Lots Road Power Station And Chelsea Creek

Lots Road Power Station Contamination Issues

Planning Permission Ref. PP/02/01324 - Submission of Details Pursuant to Condition 27

Lots Road Preliminary Risk Assessment Comments by Environmental Health

123162 FIGURE 8.3

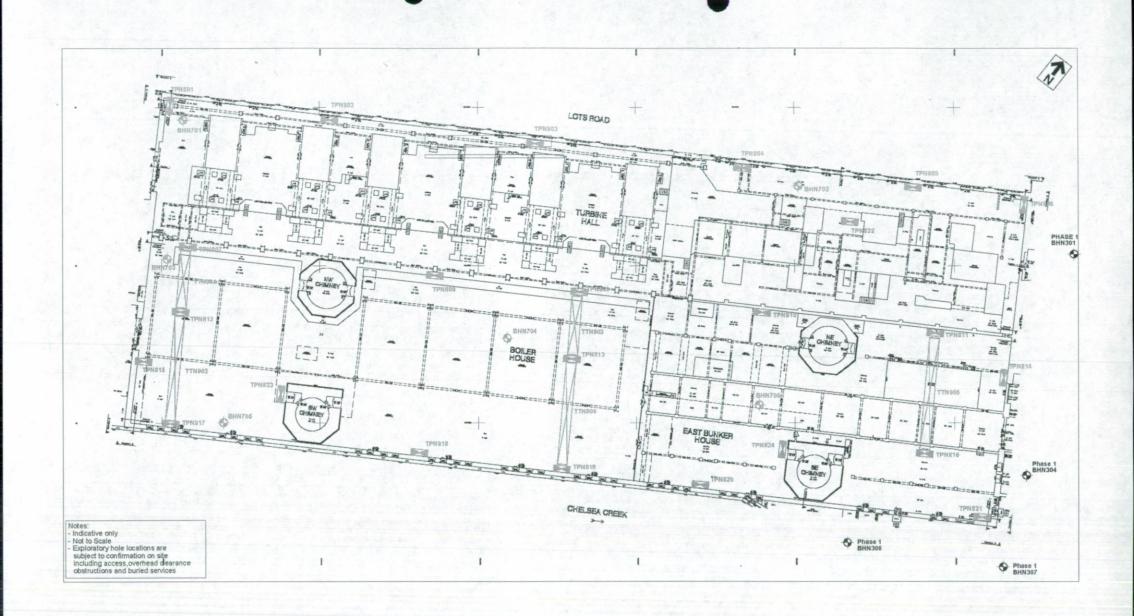
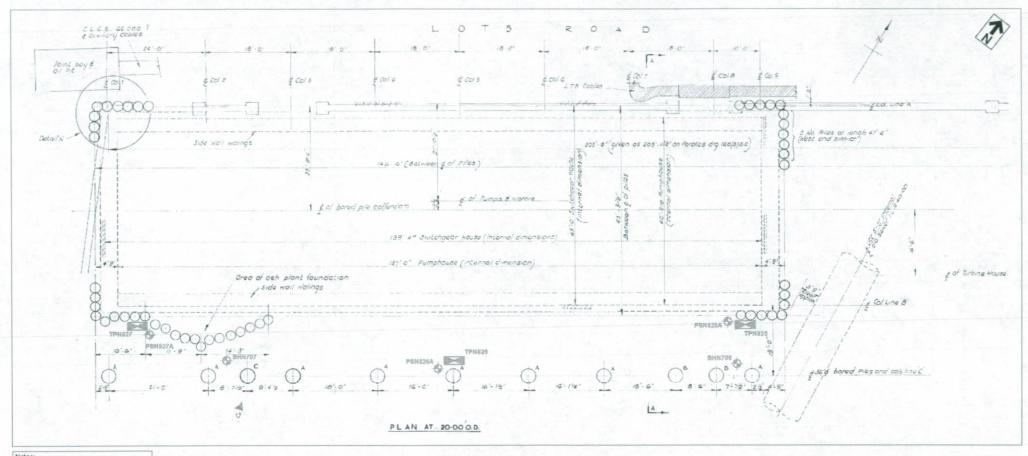
I would like to request that an additional borehole is dug, and samples taken in the area that is to become a lawn, given its proximity to the coal pit and East yard.

- the West Yard, given the presence four light oil tanks and the 100 ton tank. It is appreciated that underground cables are present, but does this preclude any investigation?
- the north east corner of the turbine hall or
- the laboratory stores.

Please explain why only three boreholes in the east of the site will be used for groundwater and gas monitoring purposes. This should be investigated on a site wide basis to see what the current situation is.

adjacent to and down gradient of the stores and should	Figure 8.1 of PRA

provide adequate information.	
Contam	27	Please explain why only three boreholes in the east of the site will be used for groundwater and gas monitoring purposes. This should be investigated on a site wide basis to see what the current situation is.	Additional locations are included within the power station and former pump house	Figure 8.2 of PRA
Contam	27	provide a map that shows that locations of pollutant hotspots identified;	Noted	Figure 6 of PRA
Contam	27	On P1 and P17 is says 'On completion of the site investigation a GQRA will be undertaken and the remedial strategy revised to incorporate the findings' (or similar). Please add a GQRA 'and a DQRA (if required)' will be undertaken and	Noted	
Contam	27	P6 refers to two oil spillages that occurred during the decommissioning process. Are any further details available on how much oil was spilt and how the spillage was dealt with?	A handover document included as part of the EIS includes only a summary of the decommissioning works and report. Detailed information is not available
